GROUP BOD	MODEL 2018MY Stinger (CK)
	NUMBER 178A	DATE February 2018
TECHNICAL SERVICE BULLETIN		
SUBJECT: SERVICE ACTION: RATTLE NOISE FROM TAILGATE (SA322A)

SERVICE ACTION: RATTLE NOISE FROM TAILGATE (SA322A)

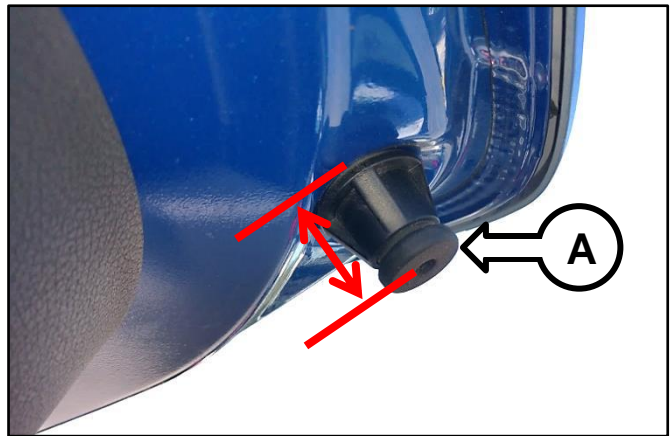
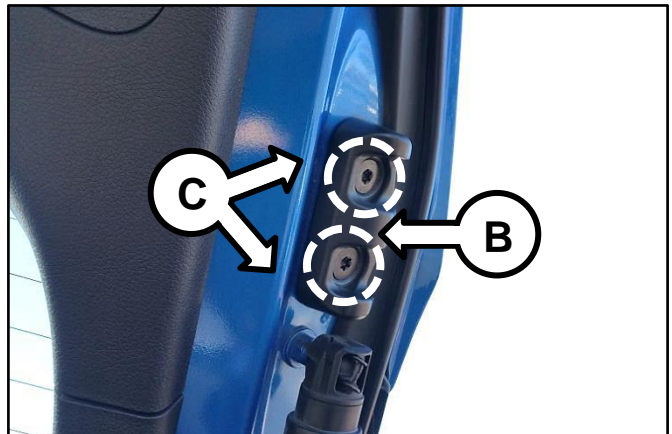
2. Check the overslam bumper (A) and adjust it within the reference protrusion specifications below. Turn the overslam bumper (A) clockwise to decrease distance. Turn it counterclockwise to increase distance if needed.

Repeat for the opposite side.

**Reference protrusion:
0.94 – 1.02 in. (24 – 26mm)**

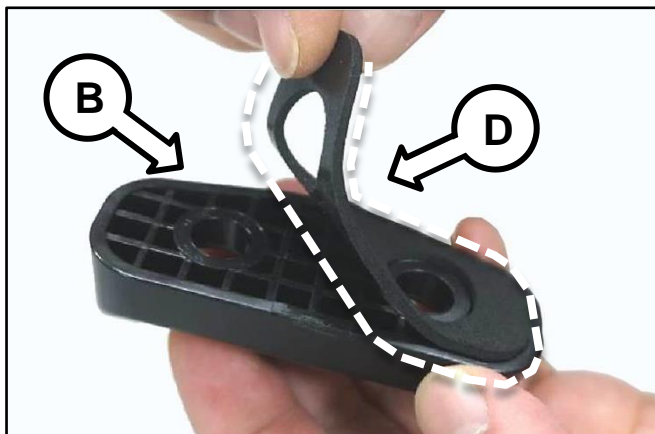
4. Remove the old pad (D) and carefully center and apply the new improved thicker pad onto the guide bumper (B).

Old Pad

New Pad

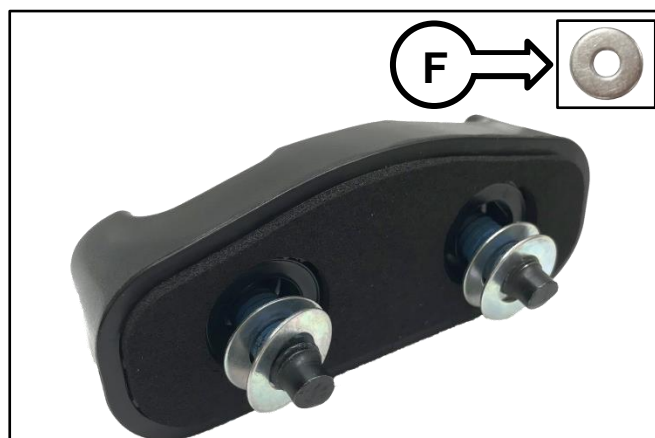
5. Insert two (2) washers (F) per bolt, as shown, and then reinstall the guide bumper (B) onto the tailgate.

Tightening Torque:

**4.3 – 4.7 lb.ft (5.83 – 6.37 N.m,
0.59 – 0.65 kgf.m)**

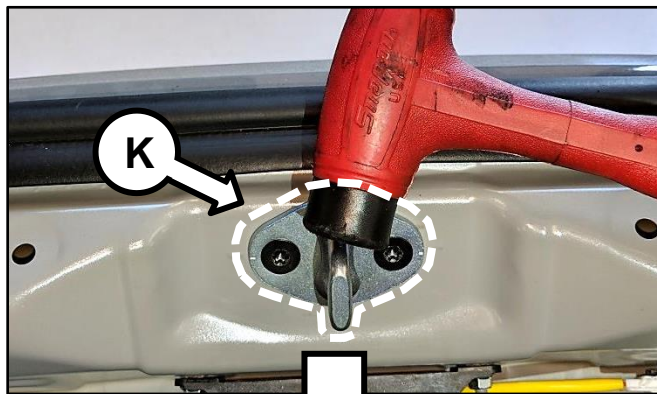
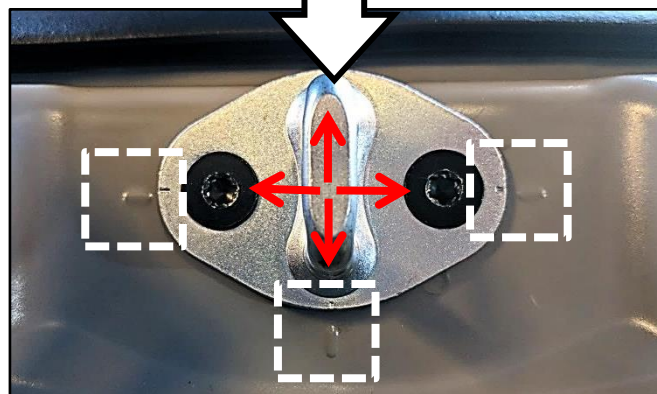
11. Adjust the striker by moderately hitting the striker (K) with a rubber hammer in the direction required, in order to align the three (3) marker guides on striker and body.

Alignment marks for reference. Striker may be moved in any direction.

12. Once adjusted, torque striker mounting bolts to specifications and ensure tailgate door latches to striker properly.

Tightening torque for bolts (J) :
15.9 – 19.5 lb.ft (21.6 - 26.5 N.m,
2.2 - 2.7 kgf.m)
